Intel[®] Pentium[®] II Xeon[™] Processor Specification Update

Release Date: November 2000

Order Number: 243776-026

Figure 1. An Example of Microcontroller Driven Thermal Management

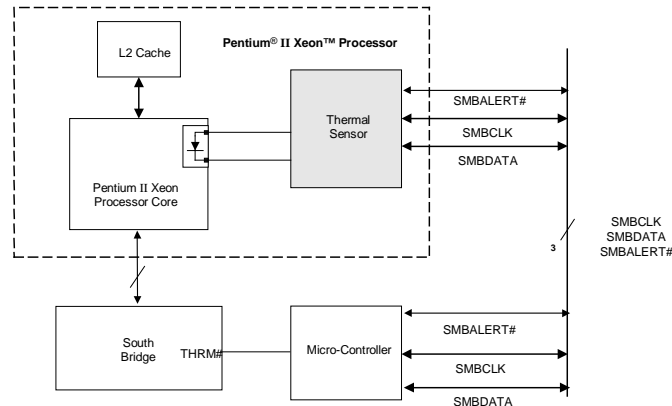
D30. Thermal Sensor May Assert SMBALERT# Incorrectly

Problem: The Pentium II Xeon processor has a thermal sensor that monitors the processor core's temperature. The thermal sensor asserts SMBALERT# if the processor temperature exceeds the temperature limits set in the Alarm Threshold Registers (T_{HIGH} , T_{LOW}). It also sets the corresponding Status Register bits to identify the cause of the interrupt. Figure 1 gives one example of how the SMBALERT# signal could be used in a system.

Under the conditions described below, the thermal sensor incorrectly generates the SMBALERT# interrupt. All of the following conditions must be met to trigger a false interrupt:

Workaround: Three different (mutually exclusive) workarounds are possible:

1. Before servicing an interrupt from the thermal sensor, read and compare the processor thermal reading with the threshold limits (T_{HIGH} or T_{LOW}). Figures 2 and 3 provide basic flowcharts for the implementation of this workaround in an interrupt driven system.
2. If the firmware implemented polls the Status Register only, then before taking any action, re-read the temperature register and do a comparison with the alarm threshold limits (T_{HIGH} or T_{LOW}) to determine if the value is actually still within the temperature window.
3. Use a temperature polling scheme to monitor the processor temperature
